SEWAGE DISPOSAL SYSTEM

DEPARTMENT OF HEALTH AND MENTAL HYGIENE

SUBDIVISION King's Gift

LOCATION SURVEY LOT 48  
**KINGS GIFT**  
 3rd ELECTION DISTRICT  
 HARFORD COUNTY, MARYLAND  
 DATE: MARCH 27, 2001

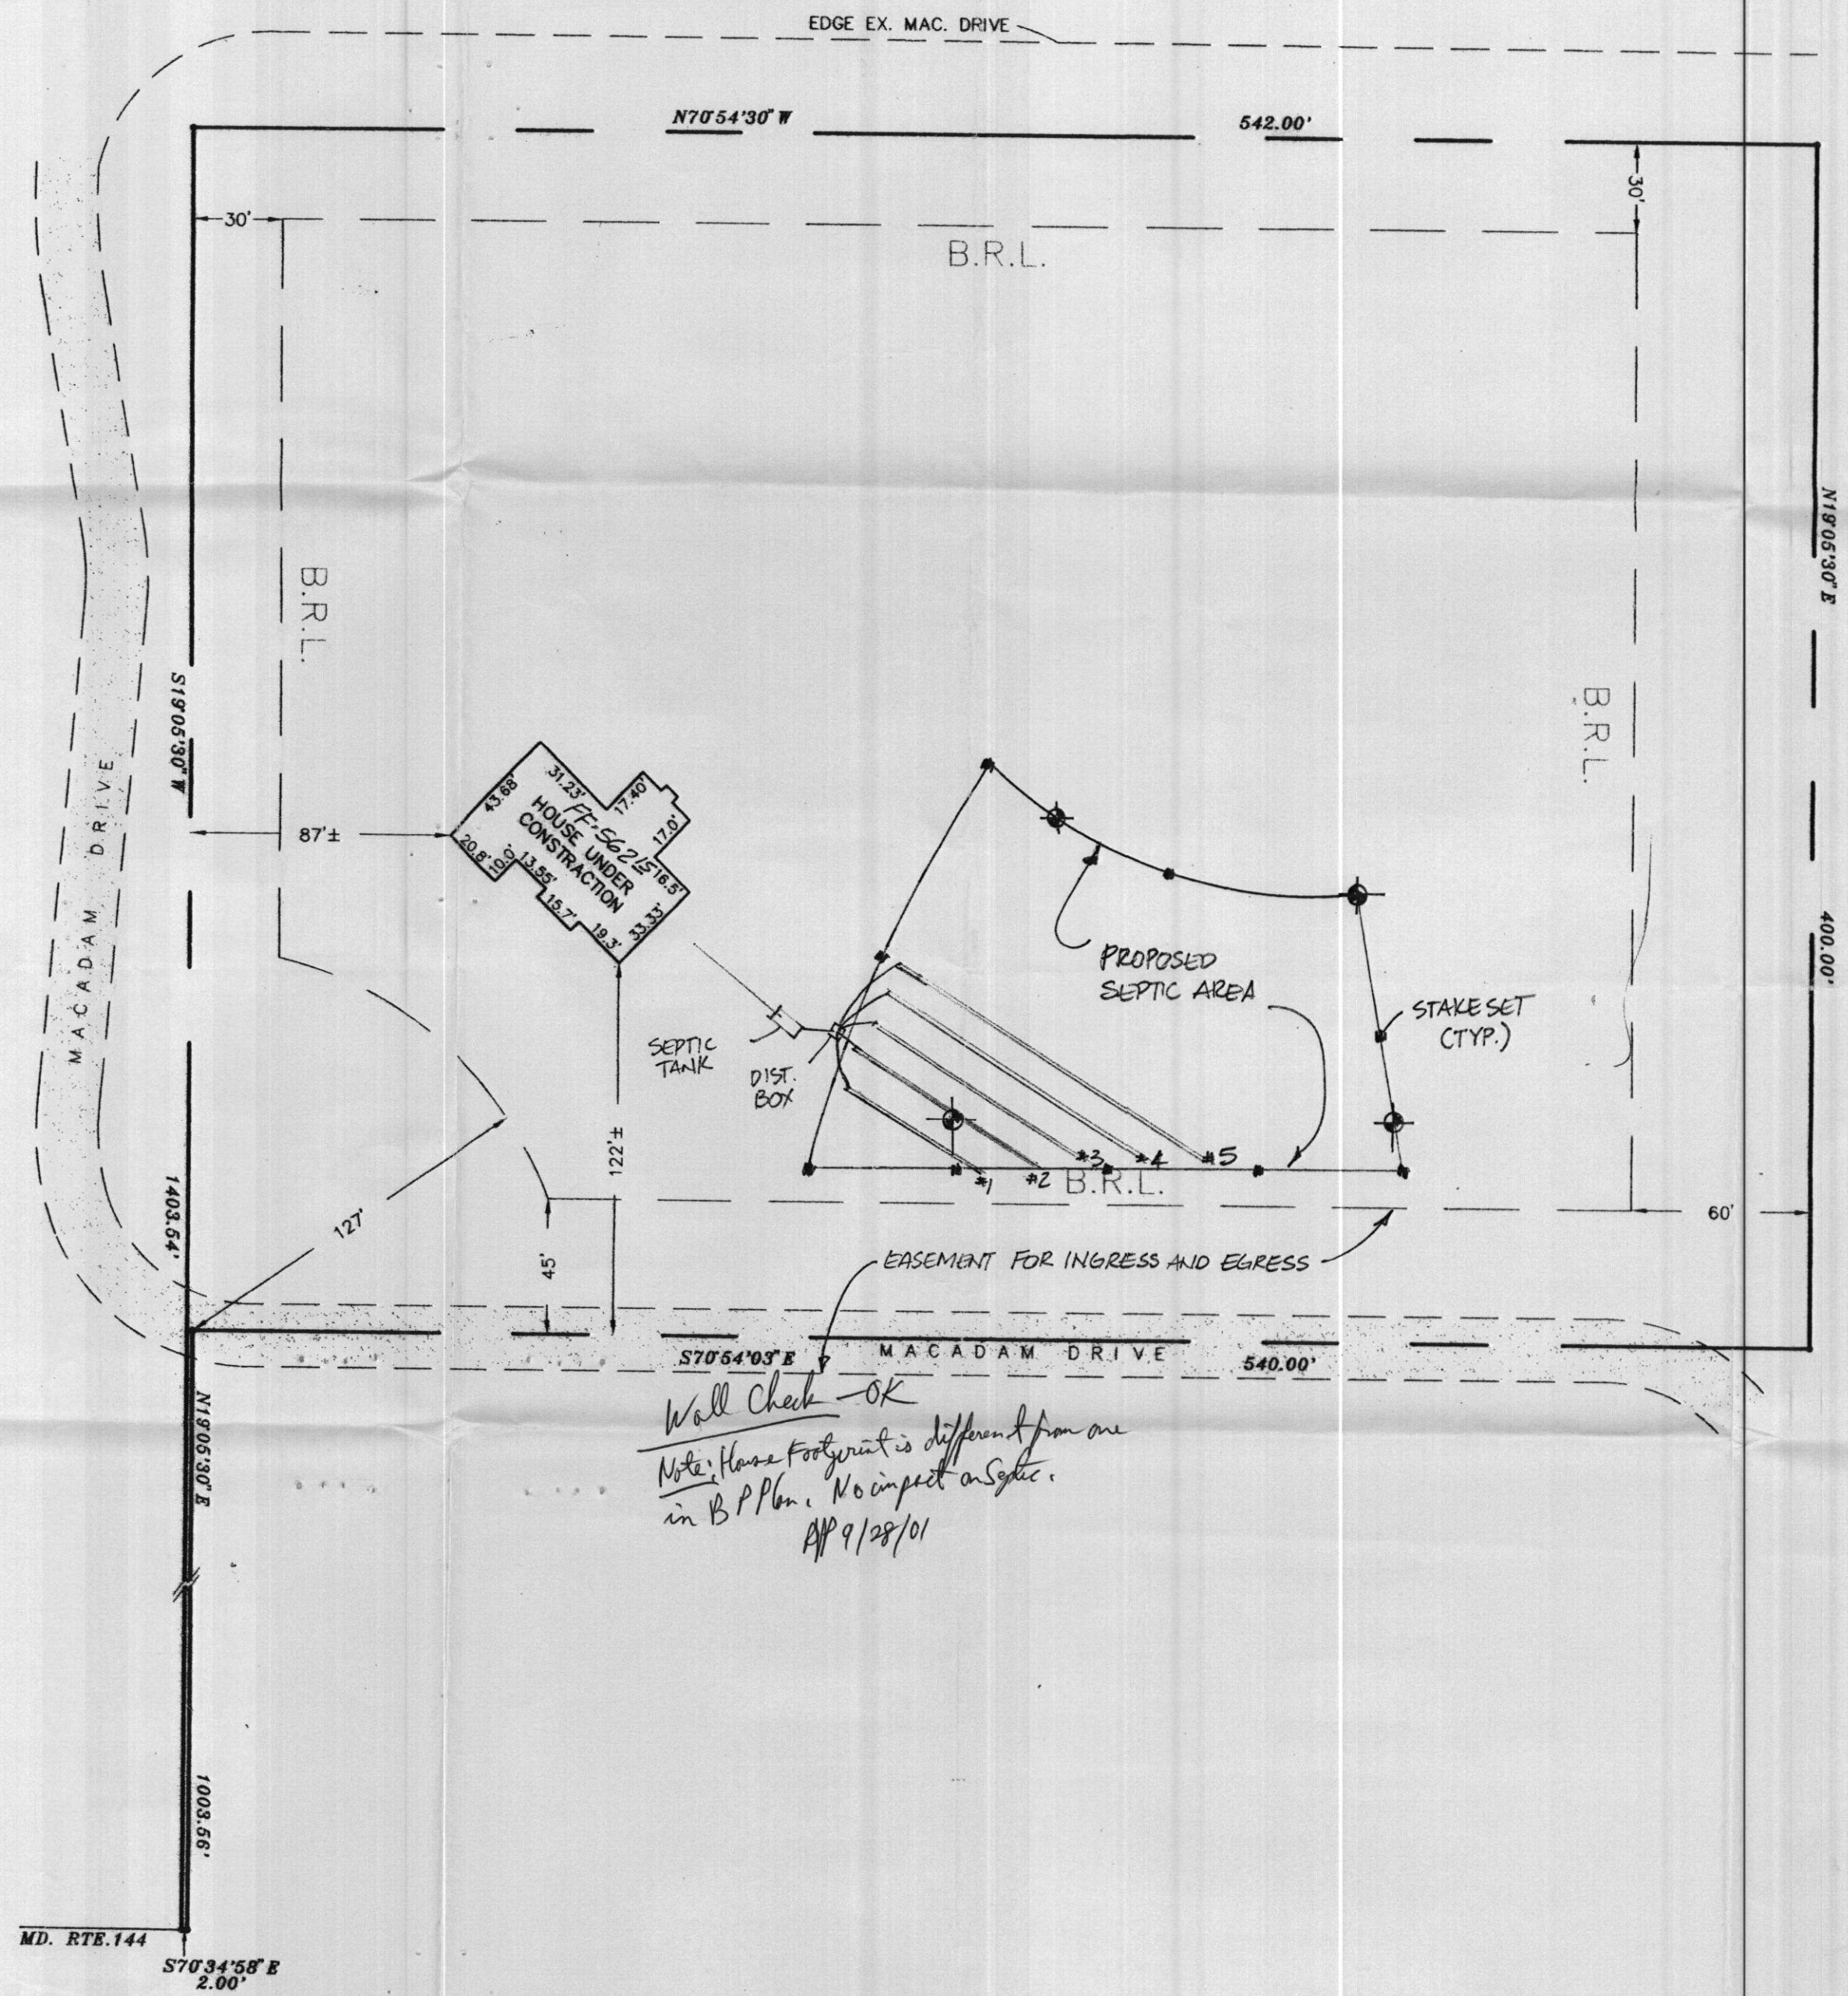
REMARKS: 10/9/01 - LAYOUT WAIVED, INSTALLER REPORTS PUMP TANK/SYSTEM NOT REQUIRED

INLET CAN BE MADE AT 4', KEEP TRENCHES 7' ETE (10' CTC) (SRV)

10/9/01 Lines 1(2)(3)(4) covered, Line 5 uncovered, prepared, grouted, & piped. House line not connected. House changed - 4500 sq ft w/ 4 bedrooms

Wall Check - OK  
 Note: House Footprint is different from one in B.P. Plan. No impact on Septic.  
 AP 9/28/01
